- Transmission: 722.403 & 414
- Subject: Harsh 1-2, 2-3 or 3-4 shifts
- Application: Mercedes

722.403 and 722.414

Harsh 1-2, 2-3 or 3-4 Shifts

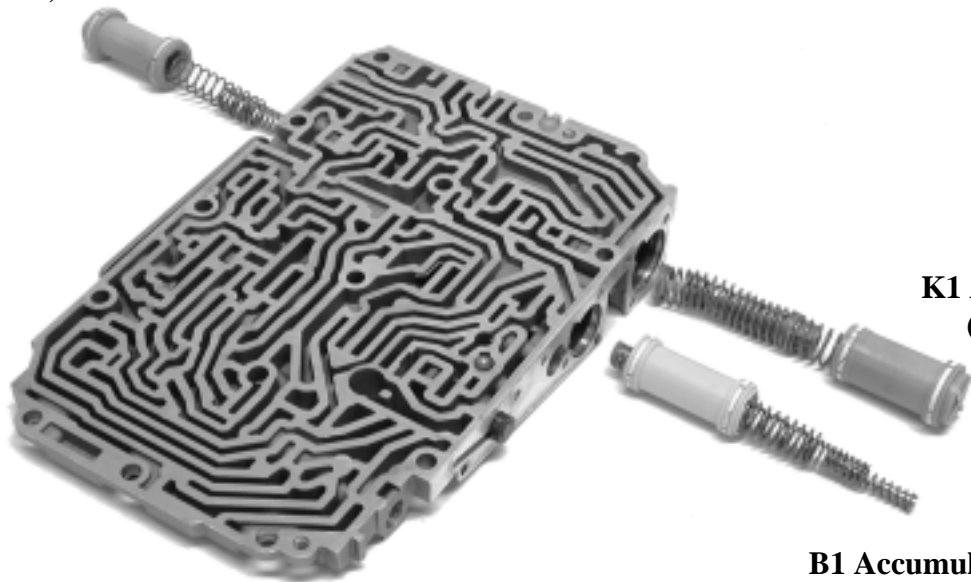
Mercedes has released new accumulator assemblies for the 722.403 (190D 2.2L) and 722.414 (190D 2.5L) units to combat harsh shift complaints. You can resolve these complaints by using these parts:

Harsh 1-2 Shift	124 270 0035
Harsh 2-3 Shift	126 270 03 35
Harsh 3-4 Shift (722.403)	126 270 04 35
Harsh 3-4 Shift (722.414)	126 270 05 35
